14th February 2017

Application SSD 16_7684 - 241-249 Wheat Road, Cockle Bay Wharf Development

Figure 1 – Potential Tower Form (Source: EIS)

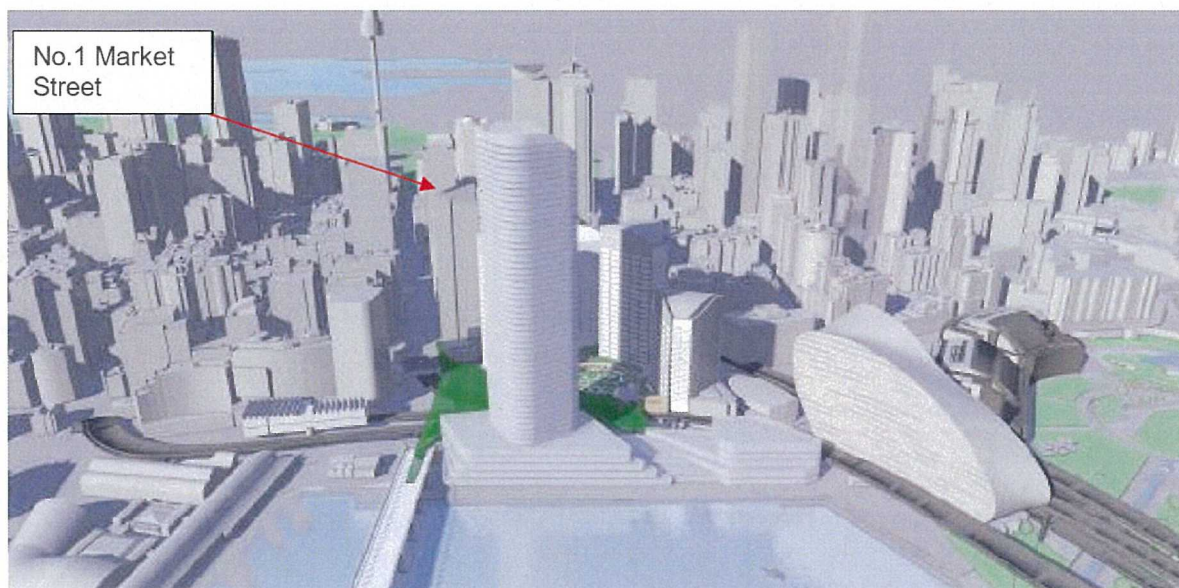
The proposed development would also have a specific impact on No.1 Market Street. The height of the building would significantly block westerly views from the upper floors across to Darling Harbour. The scale of the proposed development is illustrated on Figure 1 below. This indicates how the overall height and bulk of the proposal is evidently out of context and would block many views of Darling Harbour from existing surrounding developments.

Submission No.1

The proposed building should be reduced in height and positioned further south on the site to protect views along Market Street towards Darling Harbour.

Figure 2 – Current Building Heights (source: EIS)

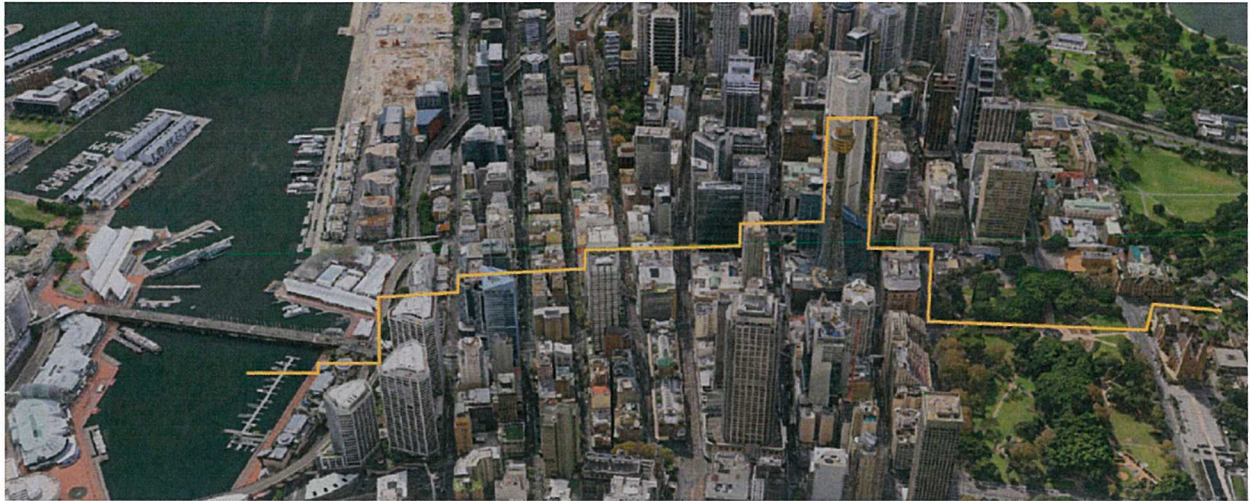
As illustrated in Figure 2, the existing building heights step down from high rise in the CBD, to medium rise at Darling Park and then low rise on the waterfront. The proposed tower would therefore significantly alter this skyline and introduce a new large tower form which is taller than No.1 Market Street, adjacent to the Darling Harbour foreshore.

Submission No.2

The existing built form character of Central Sydney which provides for built form to step down in height towards the western waterfront should be respected. Therefore, the height of the proposed development should be more consistent with the existing built form in the immediate surrounds.
